ADDENDUM NO. 1

This addendum includes Item Number 1-1 thru 1-76. This addendum item shall be fully incorporated into the Bidding/Contract Documents and have the same force and effect as though originally included.

Life Sciences Collaboration
1910 N. Antelope Valley Parkway
Lincoln, Nebraska
TCEP No.: 716-002-12
Davis Design.: 12-0077
BVH No.: L12018.unl
November 27, 2013

Item 1-42: Sheet A2.01- Exterior Building Elevations – Area A

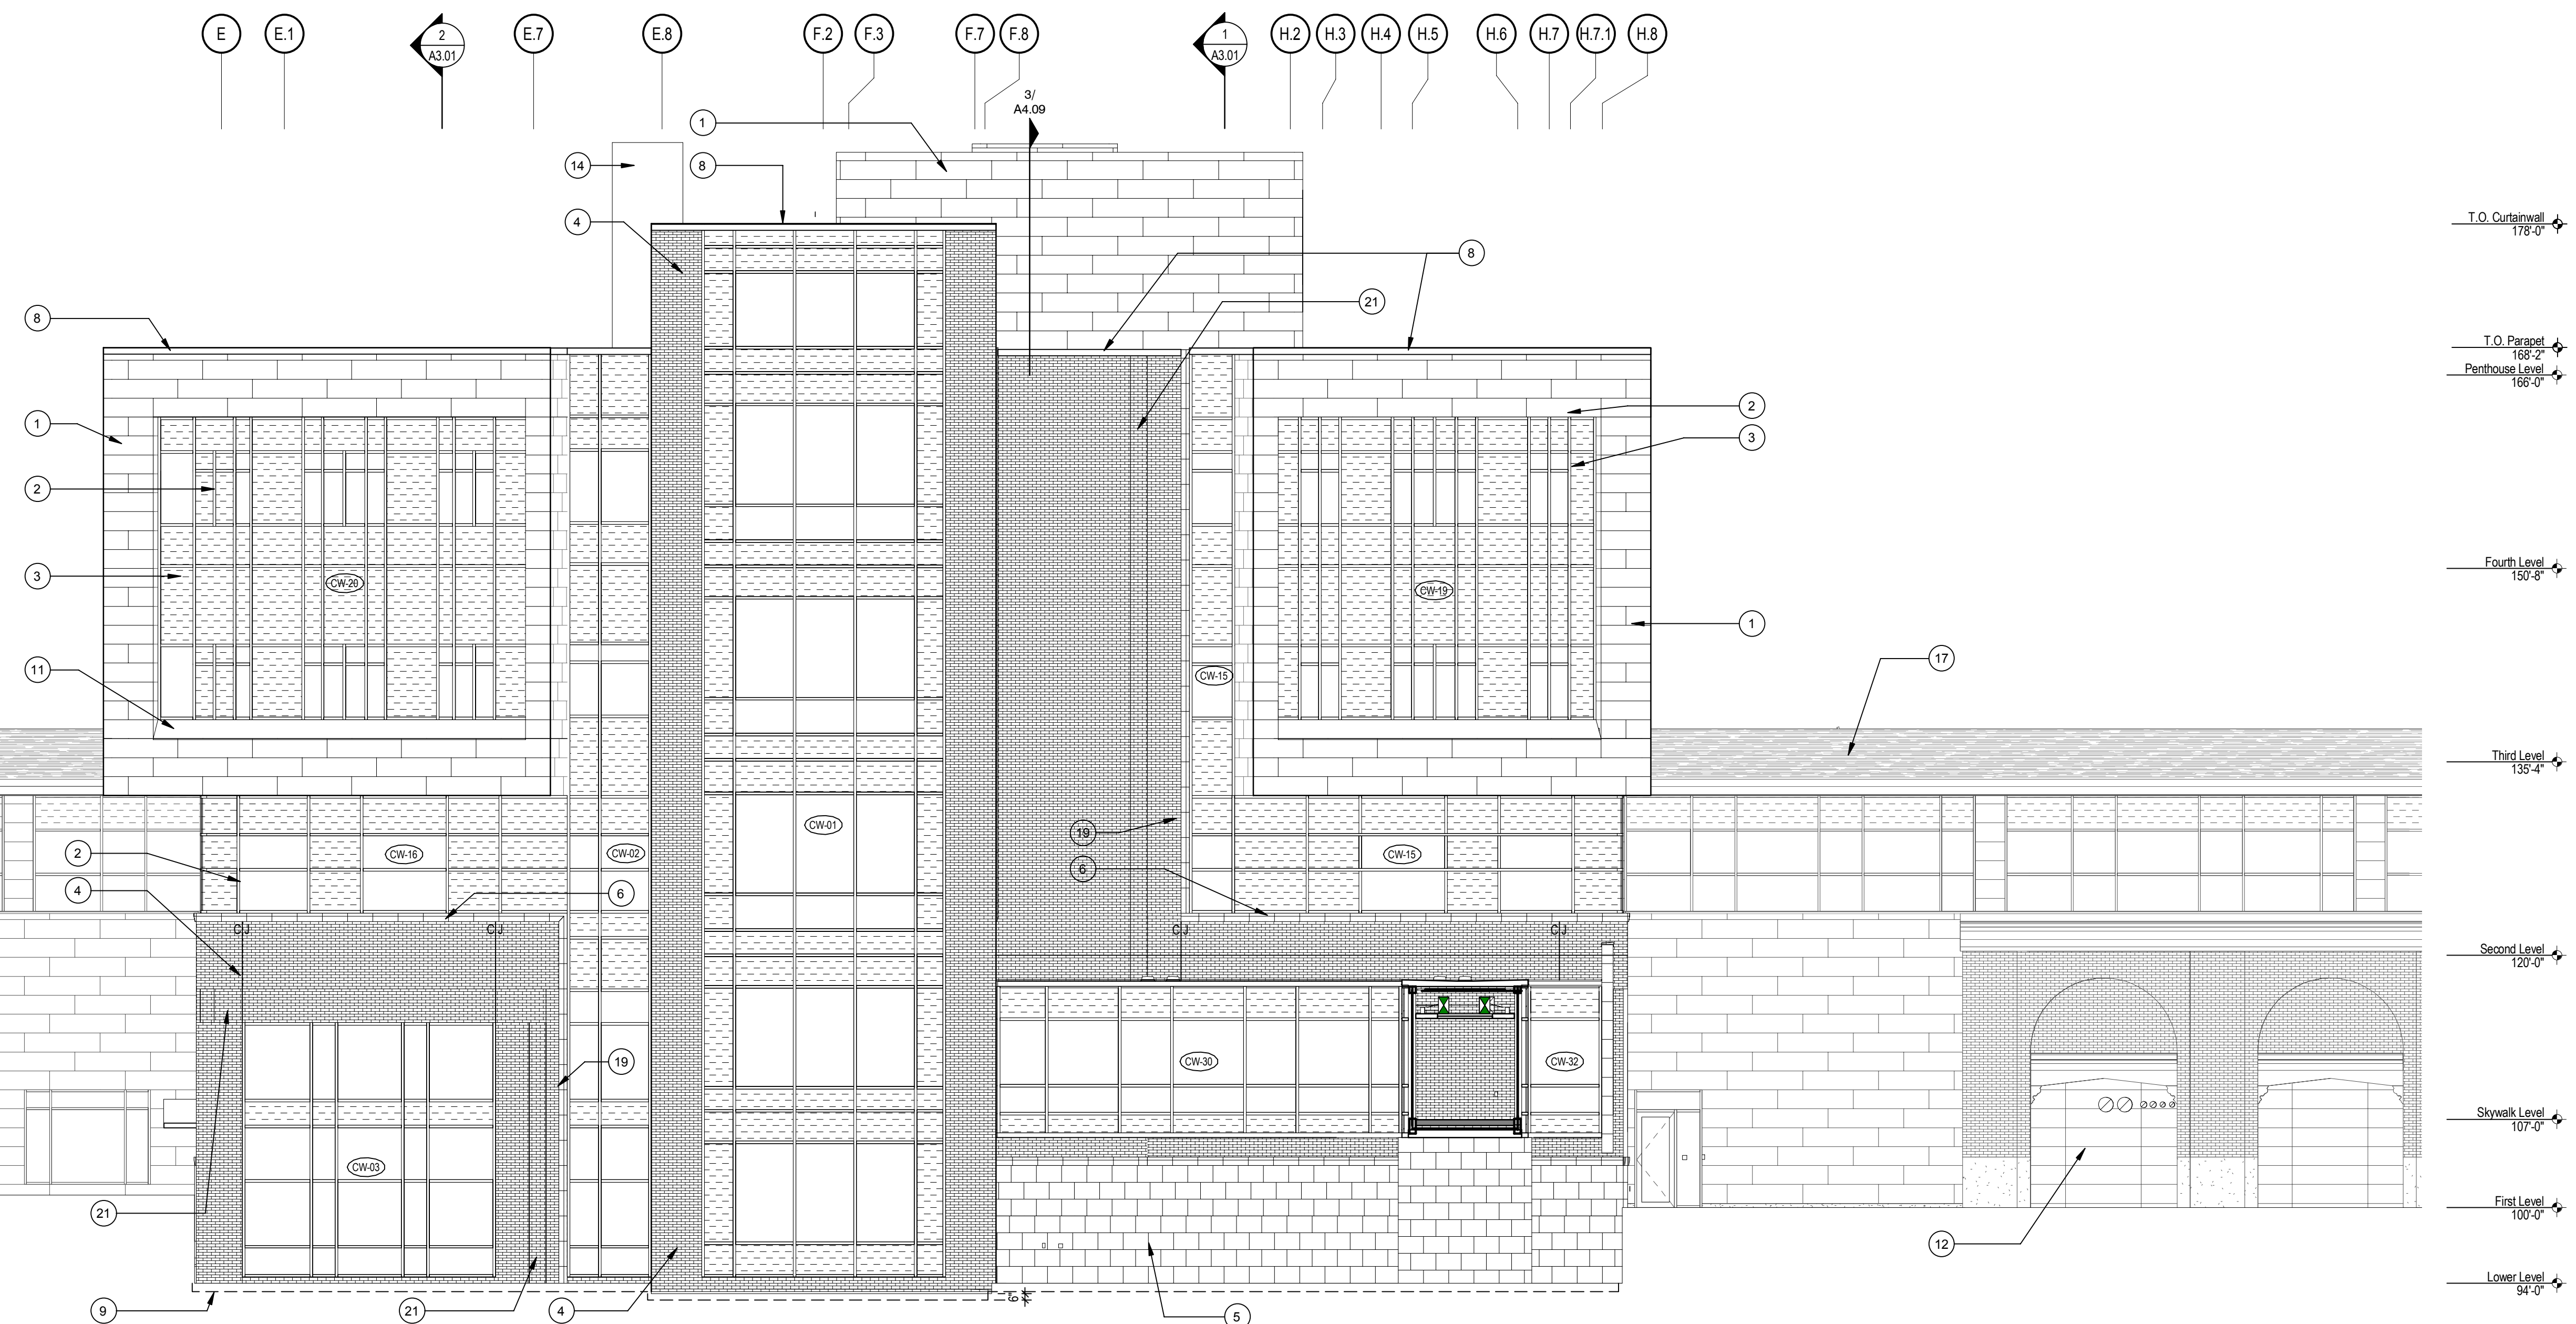
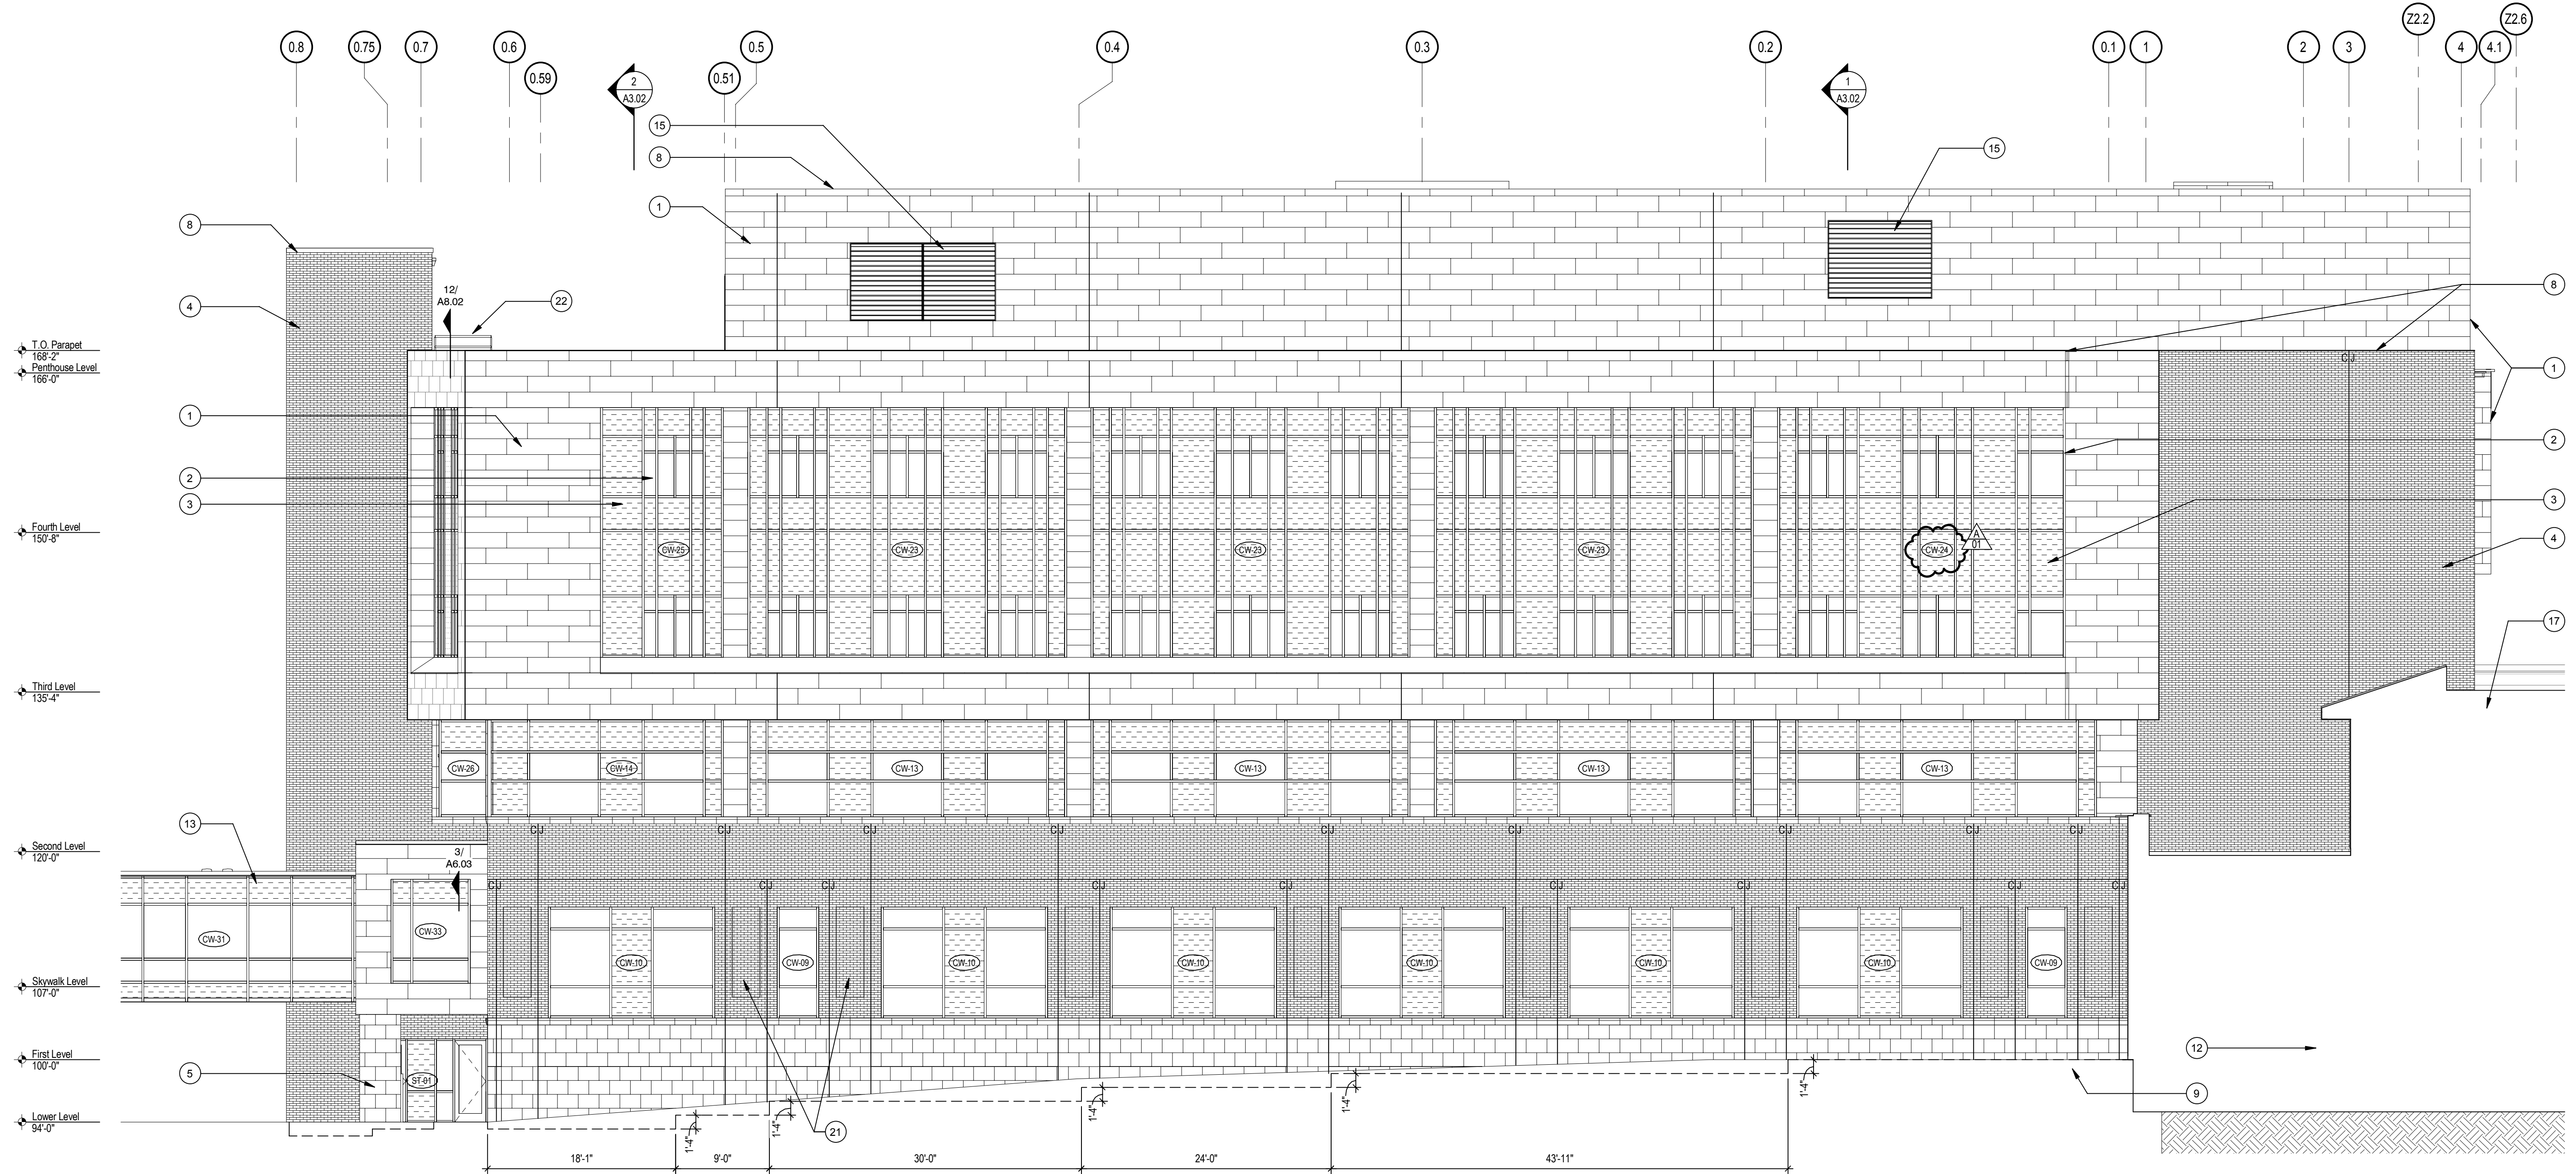
See revised sheet for updated Curtainwall frame type reference tags. A portion of the Second Floor Addition at IAB is now shown in the East Elevation.
